Groundwater Transfer Review Summary Form

Transfer/PA # T- 13246

Application: **T-13246**

Applicant Name: **Scott & Jose Tobiasson**

Groundwater Transfer Application T-13246

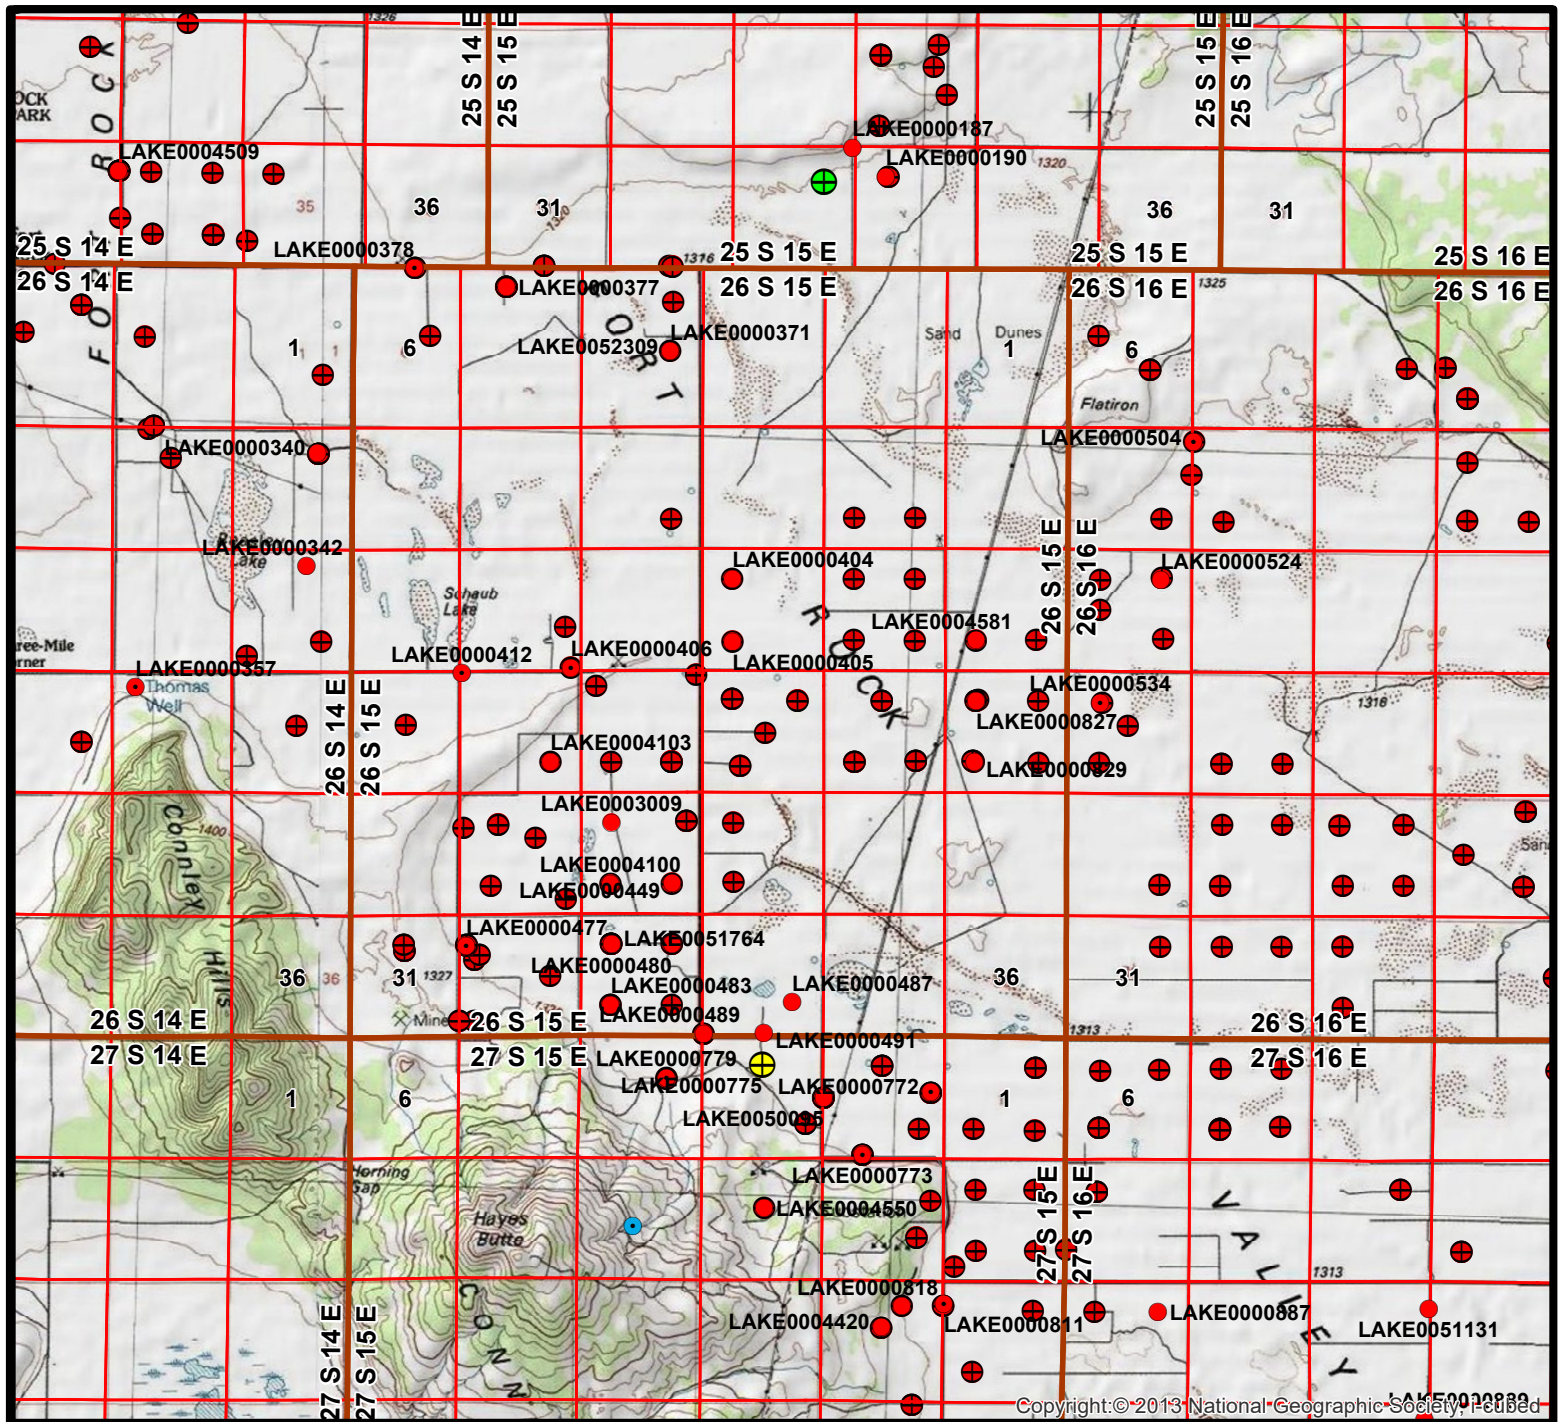
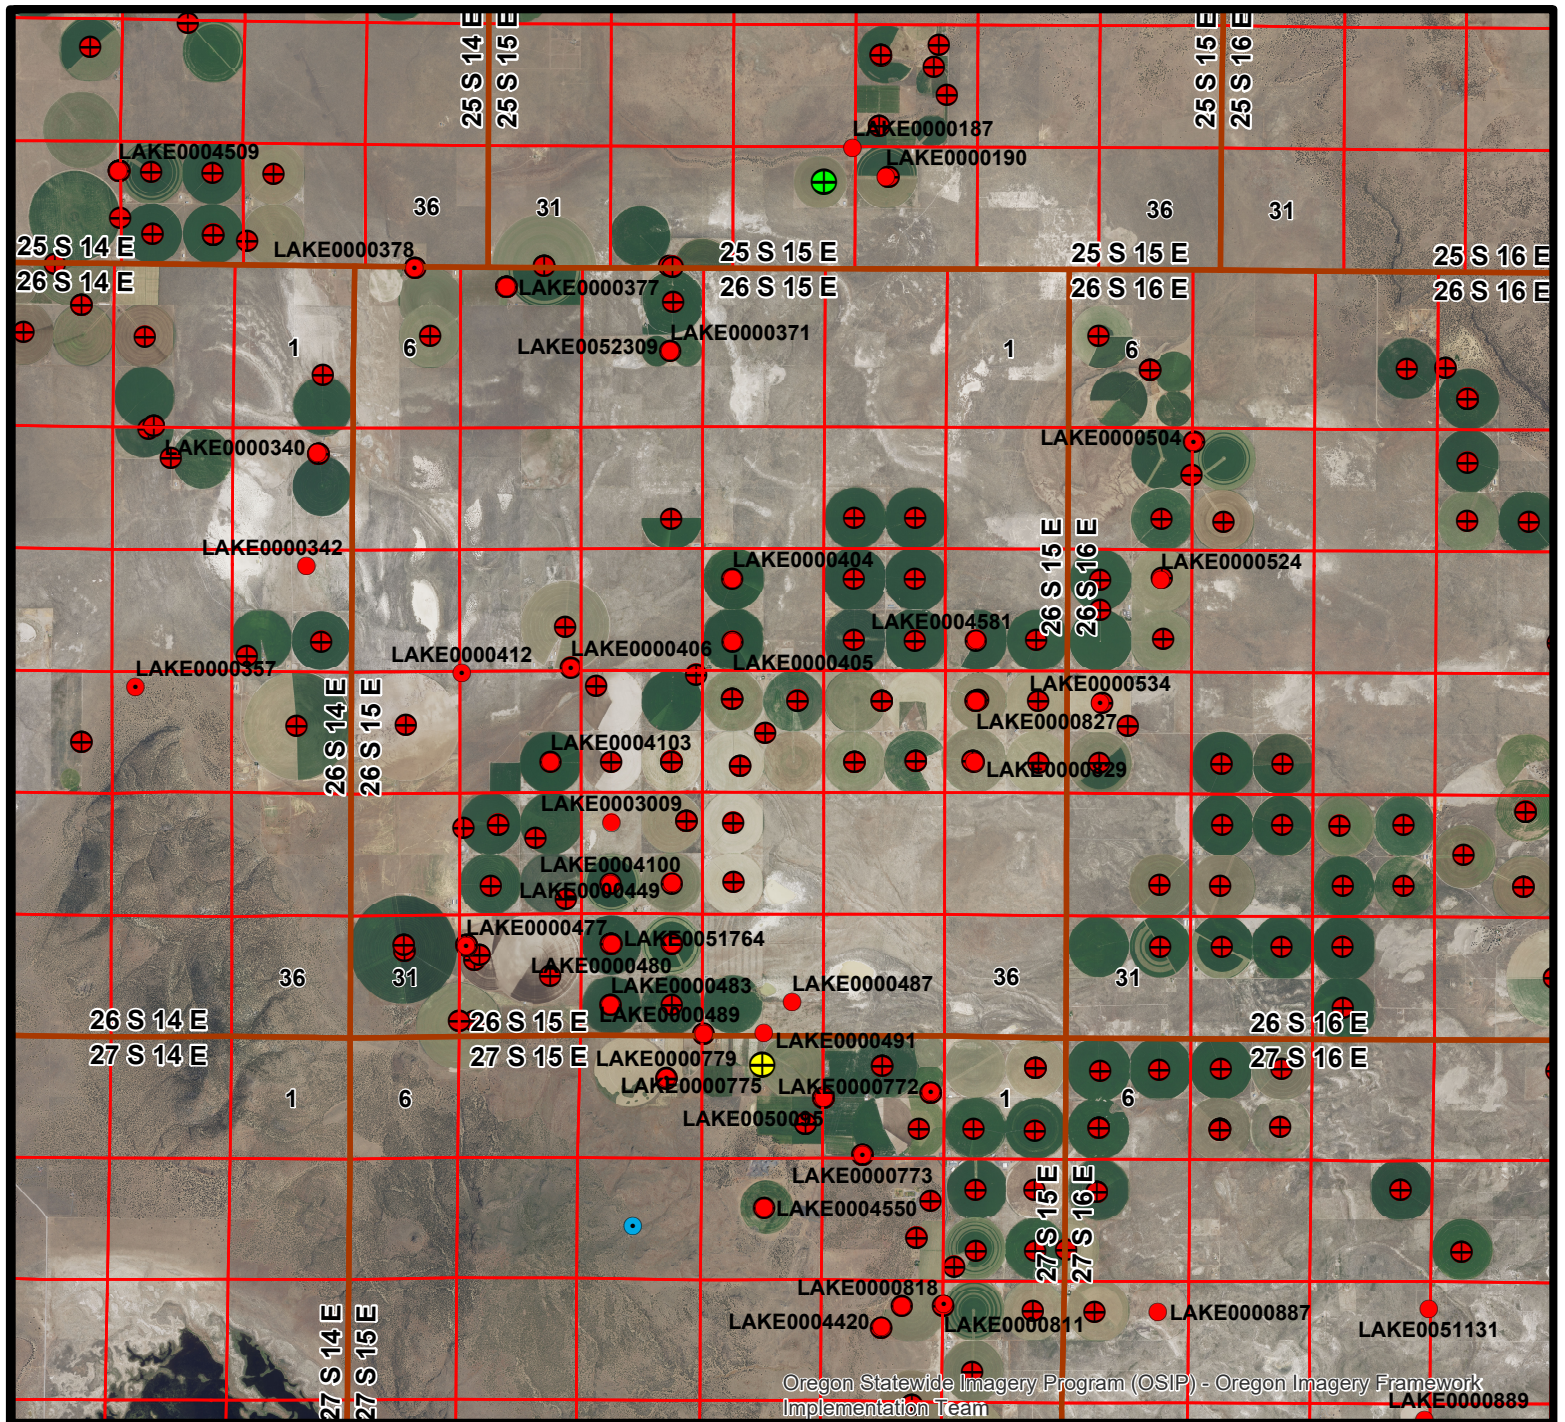
The transfer proposes the following changes. For certificate 83439, move 0.288 cfs to irrigate 23.04 POU acres from authorized POA well LAKE 775 (authorized POU & POA in T27S/R15E-sec 3) to proposed POU acreage and proposed POA well LAKE 188 in T25S/R15E-sec 33. For certificate 88683, move 0.087 cfs to irrigate 6.96 POU acres from authorized POA well LAKE 775 (authorized POU & POA in T27S/R15E-sec) 3 to proposed POU acreage and proposed POA well LAKE 188 in T25S/R15E-sec 33.

The proposed POA well change will move groundwater pumping under this certificate closer to other water right wells. The calculated maximum additional seasonal groundwater level drawdown at the water right well (LAKE 187) closest to the proposed POA well (LAKE 188) is less than 1.25 feet. The change in seasonal groundwater level drawdown will be less at wells further away. All these water right wells should be able to accommodate the seasonal drawdown change.

Observation Well Data

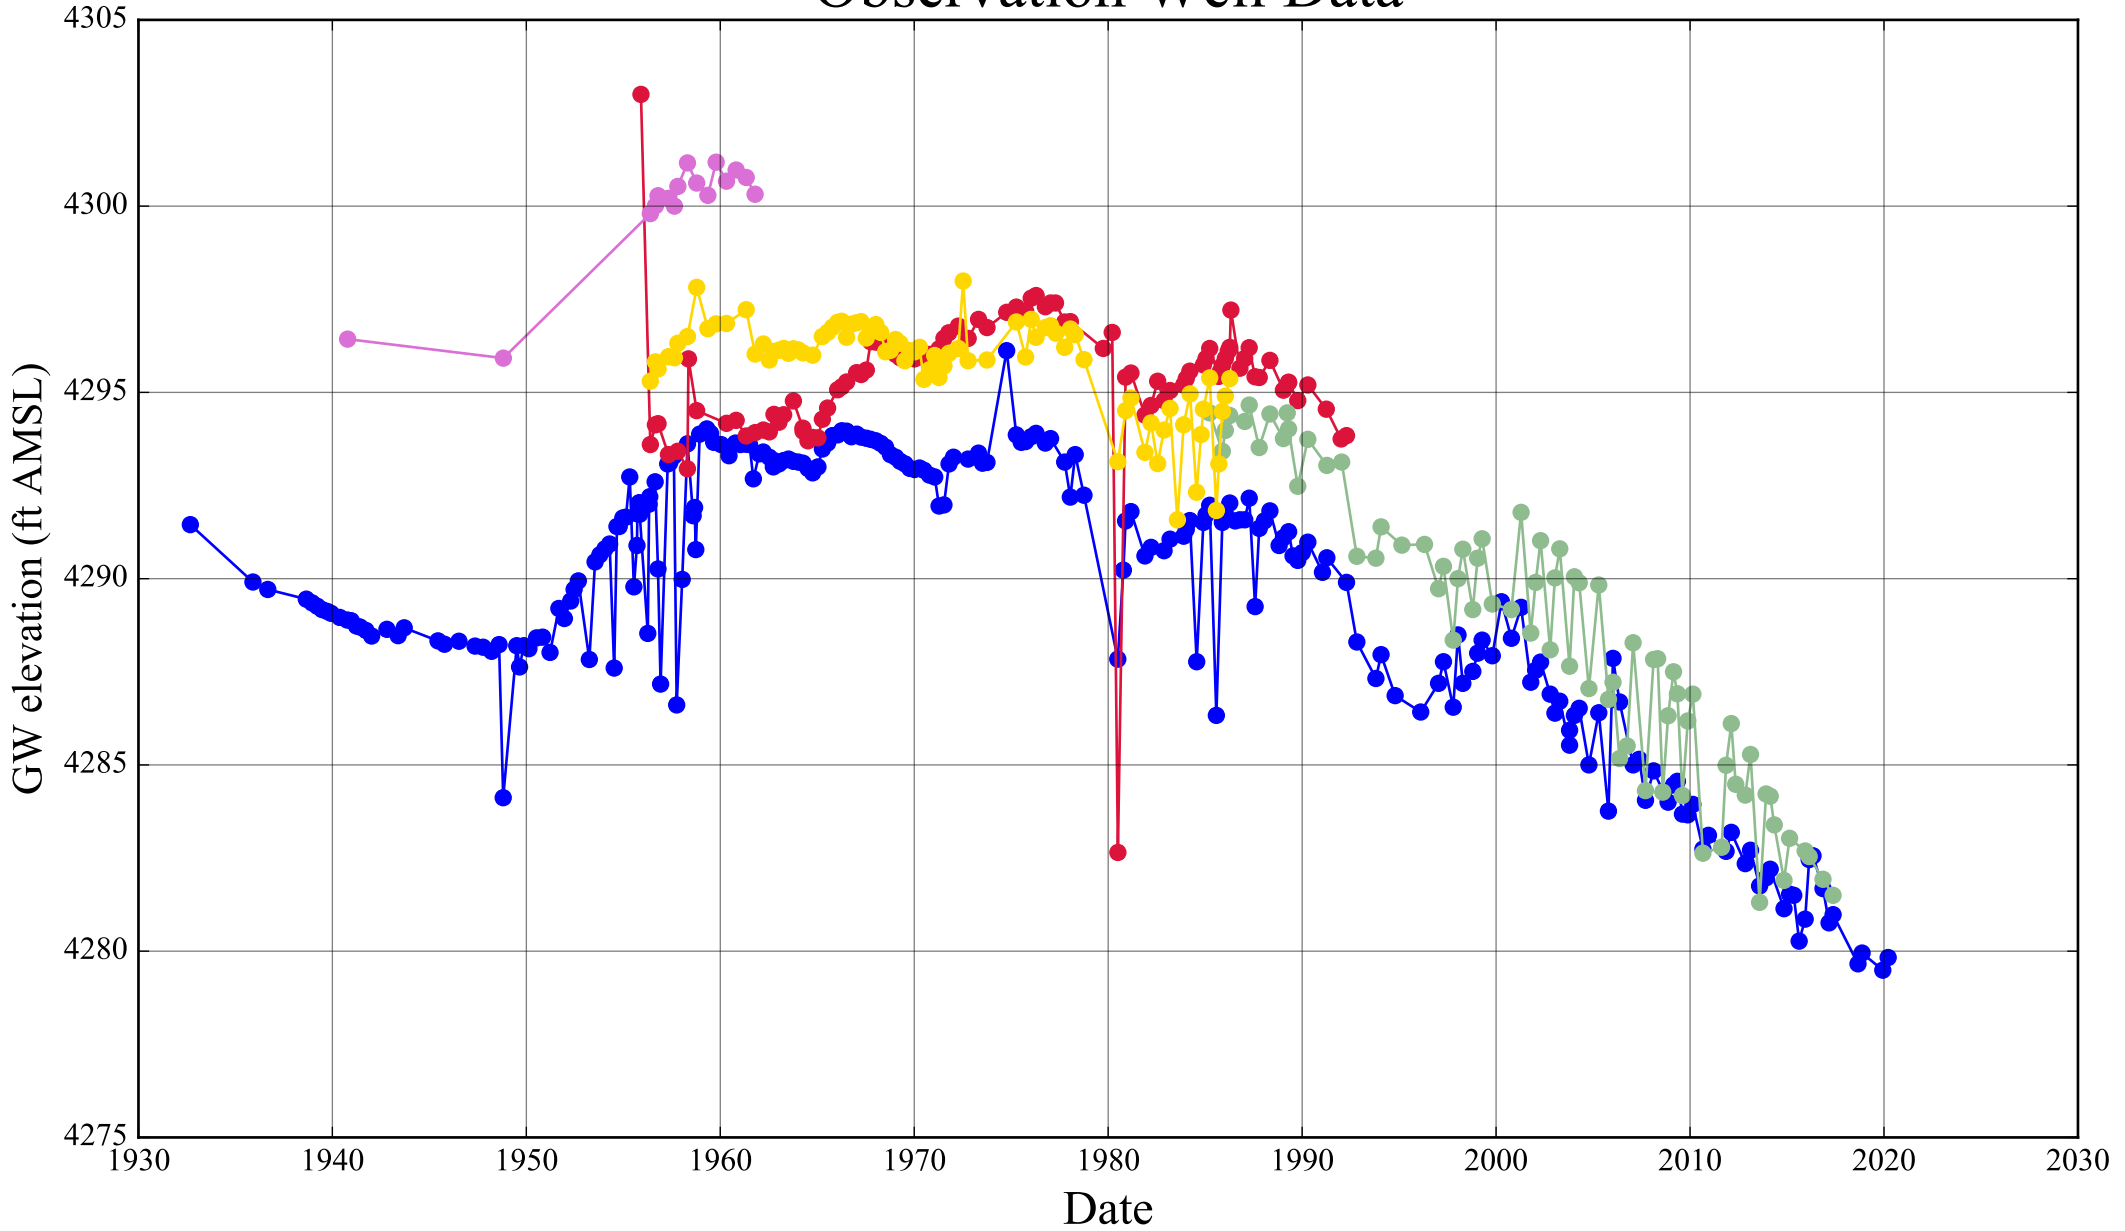
Yes, the same aquifer is likely given the same groundwater system will likely be tapped despite the proposed POA well (Lake 188) is 200 feet deeper than the authorized POA well LAKE 775 (280 ft. blsd vs. 75 ft. blsd). Long term groundwater level data indicates groundwater levels at wells surrounding the currently authorized and proposed POA locations have similar elevations, seasonally fluctuate similarly, and show the same long-term trends (see attached hydrograph).

The long-term impact on the groundwater system should be the same. That impact is to continue contributing its ongoing share to the annual Fort Rock Classified Area groundwater level decline (see the attached hydrograph...it shows an annual decline rate of about 0.25 feet per year).
